**City of West Linn  
PRE-APPLICATION CONFERENCE MEETING  
SUMMARY NOTES  
March 17, 2011**

**SUBJECT:** Proposed Accessory Dwelling Unit (ADU) at 2590 Oxford Street

**ATTENDEES:** Applicants: Nathan Pylate  
Staff: Peter Spir (Planning) Jim Clark (Building)

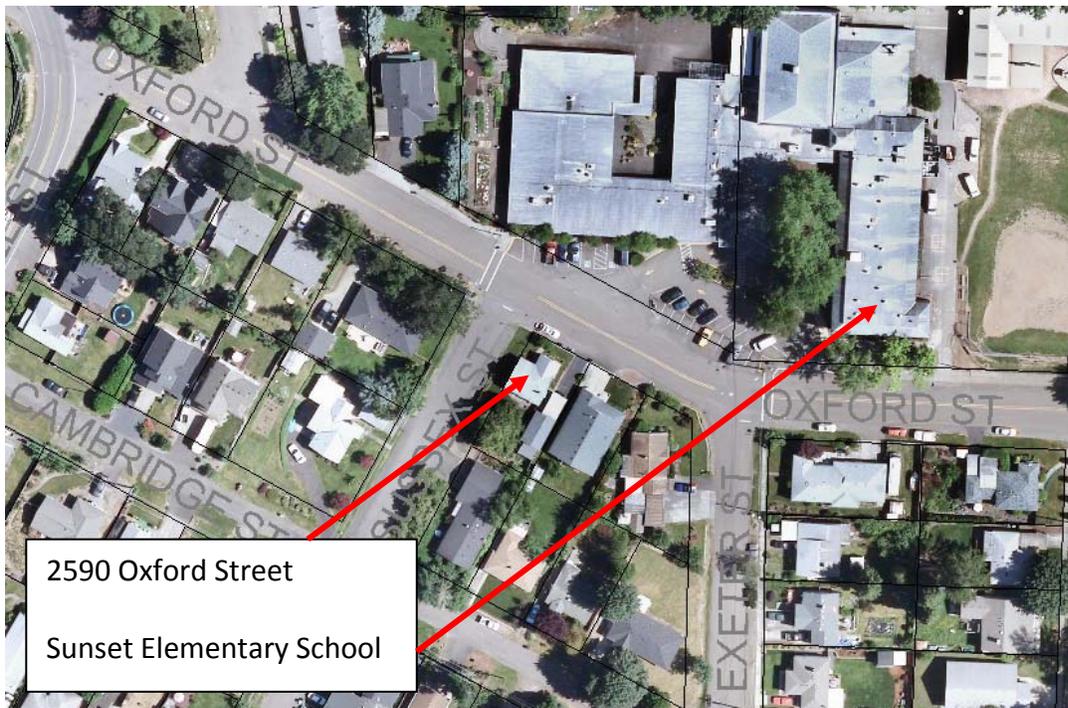
The garage architecture and materials used suggest that it was built somewhere between 1950 and 1960, well before January 2000, so its conversion to a 420 square foot ADU is allowed. The applicant proposes to add a window on the west side of the garage with no windows on the east side facing the neighbor. The building is and will remain 14 feet tall to peak of roof which is a single story structure. The entrance door will remain on the north elevation.

Staff finds that changing the use from a garage to an ADU will not change or worsen the non-conformity. No expansion of the garage footprint is proposed and the elevation facing the neighbors will remain unchanged. The proposal will not add windows on the east side of the garage/ADU which means that the privacy the neighbors now enjoy will continue.
